**TOWNSHIP OF McNAB/BRAESIDE
COMMITTEE OF ADJUSTMENT
AGENDA**

MINOR VARIANCE PLANNING REPORT

1. FILE NO.: A-9/24
2. APPLICANT: Keith Blimkie
3. MUNICIPALITY: Township of McNab/Braeside
(geographic Township of McNab)
4. LOT: 21 CONCESSION: B STREET: 632 Caruso Circle

The application requests variances to various sections of the Township's Zoning By-law for a reduced front yard depth and a reduced southeast side yard width to permit an attached carport in the southeast side yard of this residential lot.

DRAWN: JULY 2, 2024

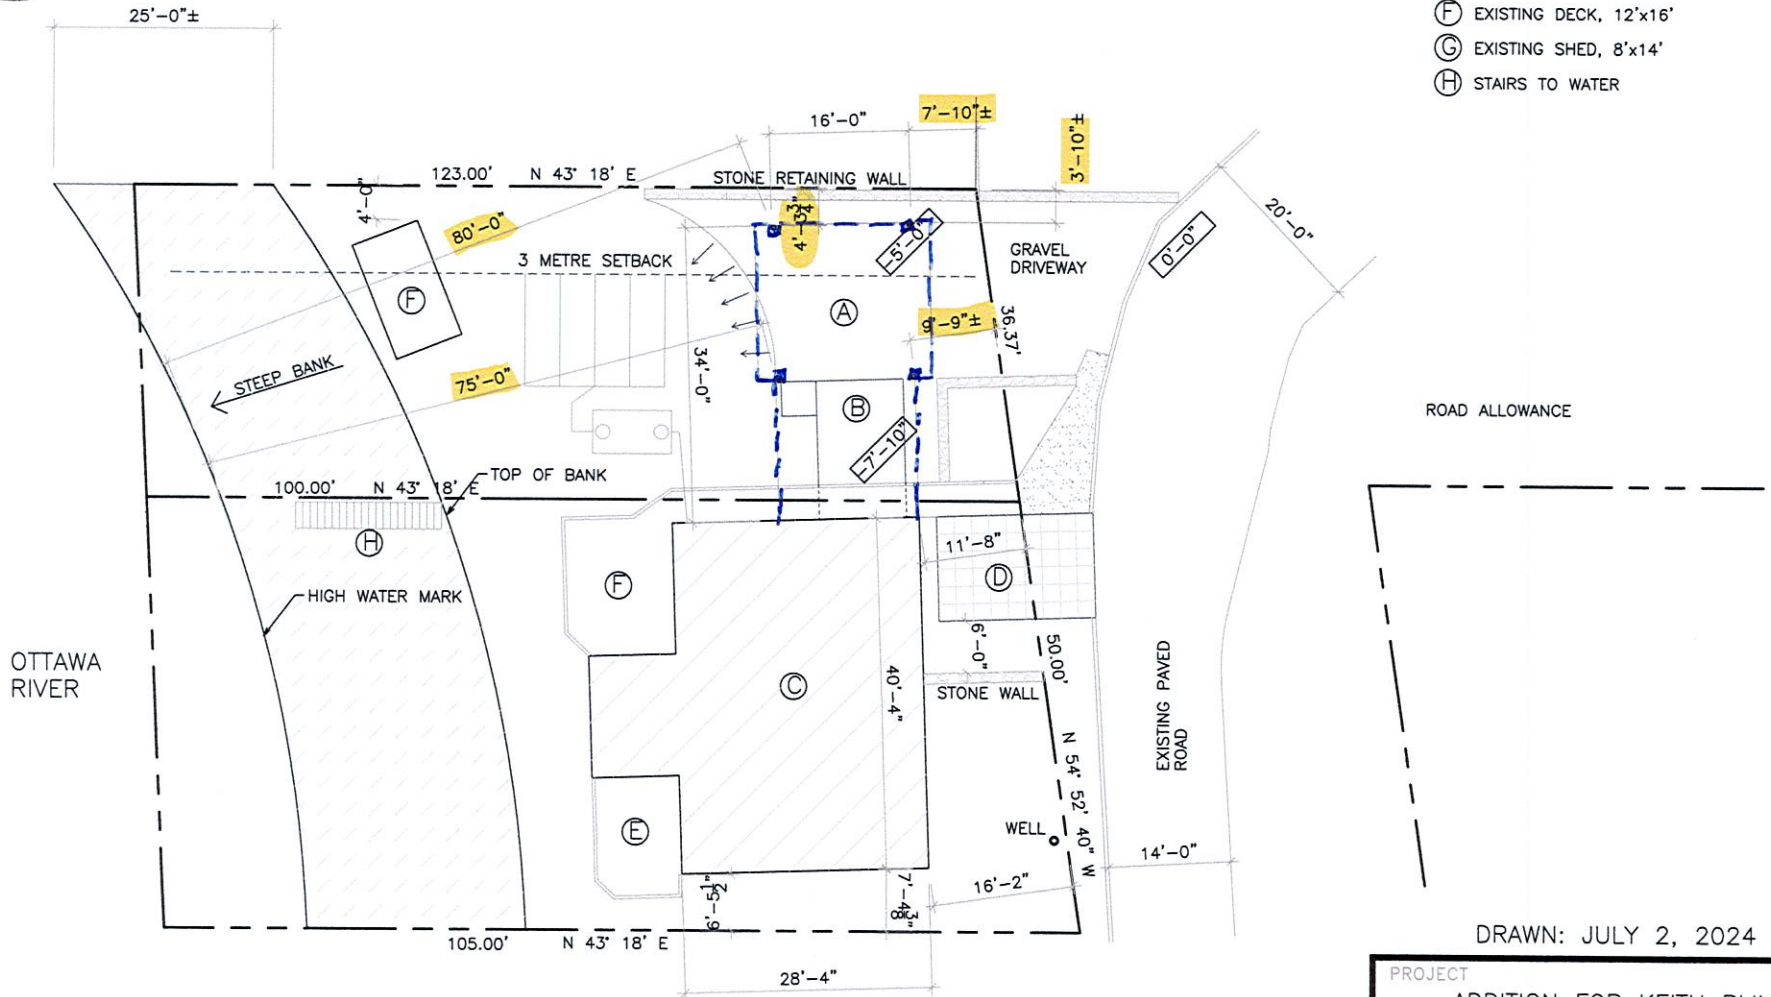
The application sketch dated July 2, 2024 identifies the high water mark and that the rear of the carport is 22.86 metres (75 feet) from that high water mark. The sketch was prepared by Mr. Jacques Benoit, who is a practicing, professional municipal chief building official and is considered as a qualified person to determine the location of a high water mark, as set out in the Official Plan policies. The proposed carport therefore meets the water setback requirements based on the circumstances of the lot.

The requested reductions to the minimum front and side yards are shown on the application sketch as being measured from the front and side lot lines to the supporting posts. The sketch shows a roof overhang extending beyond the posts at the front and back of the carport, but at the side of the carport the roof is shown being in line with the posts. However, the preliminary building elevations shows a roof overhang on the front, back and side of the carport. Section 3.8(a) Encroachments on Required Yards permits eaves to encroach in all minimum required yards a maximum of 0.6 metres.

If the carport roof is constructed as depicted in the building elevation plans with a maximum 0.6 metre eave encroachment into the requested reduced front and side yards:

- the front eave of the carport could be 1.79 m (5.8 ft) and 2.37 m (7.77 ft) from the front lot line, and
- the side eave of the carport could be 0.71 m (2.3 ft) and 0.6 m (1.97 ft) from the southeast side lot line.

PROJECT	ADDITION FOR KEITH BLIMKIE
DRAWN BY	JACQUES BENOIT
SCALE	1/8"=1'-0" U/N
REV #	0

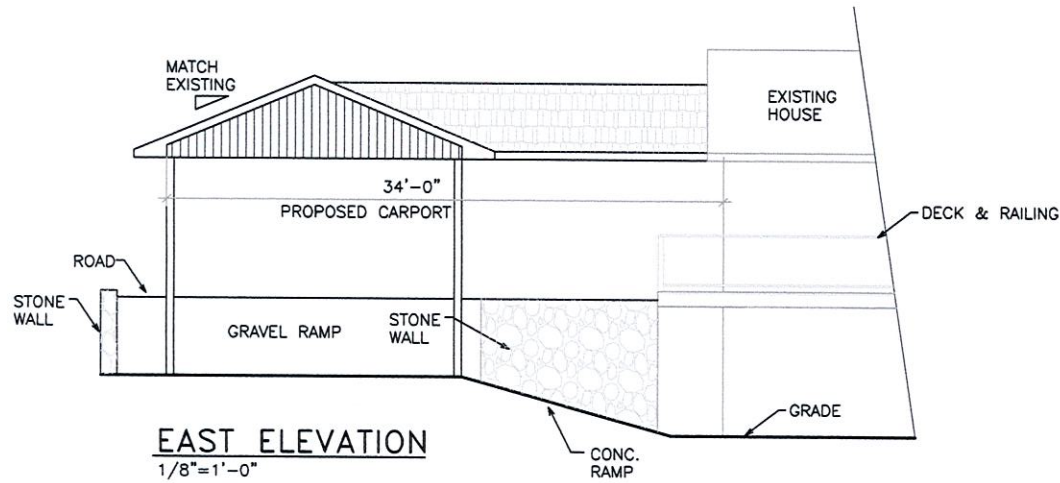
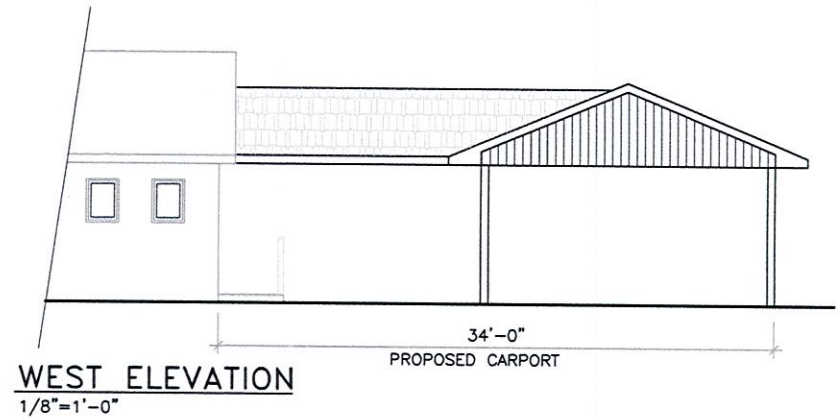
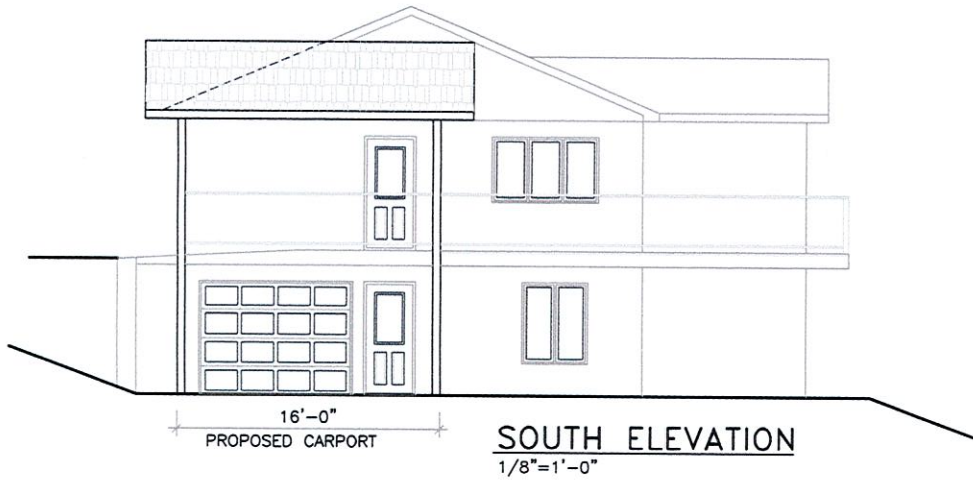
The proposed carport is described as a post and roof construction with no enclosed walls. The carport roof is proposed to extend and connect to the existing house so that it also covers the existing ramp to the basement garage. The carport would therefore be considered as part of the main dwelling, as set out in Section 3.3.7 of the Zoning By-law, and is required to meet the building setbacks for a main use in the Rural (RU) Zone, for this property.

There are no concerns with the eaves encroaching into the reduced front and rear yard setbacks provided roof stormwater is properly managed, as described in Potential Impacts, below.

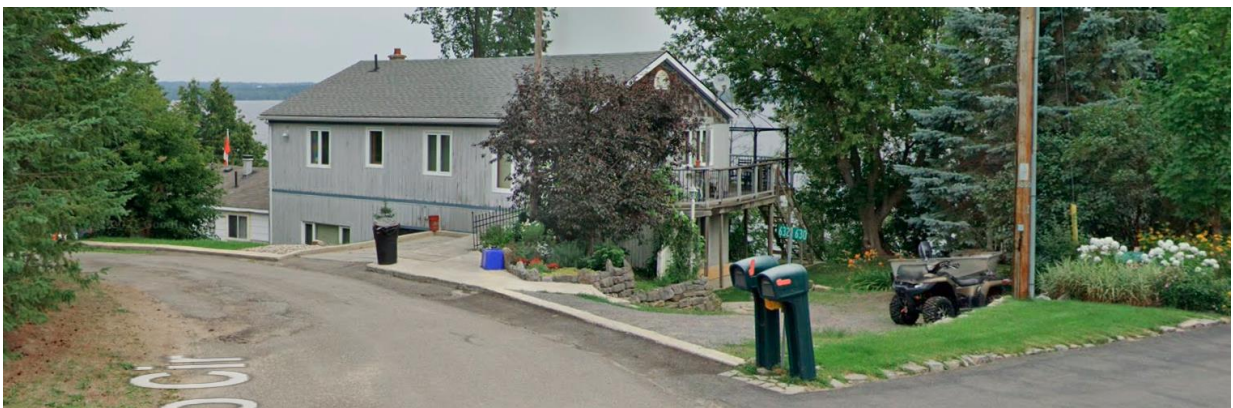
Photo 2, below, shows the existing landscaping at the front of the property, and the existing driveway leading to where the carport is proposed. The cement ramp, on the left, leading down to the basement garage is just visible. Large coniferous trees and a retaining wall are visible along the southeast lot line abutting 630 Caruso Circle.

Photo 3 shows the southeast end of the dwelling to which the carport is proposed to connect. It also shows the driveway dipping down to the proposed building site. Behind the dwelling, the lot drops off towards the Ottawa River.
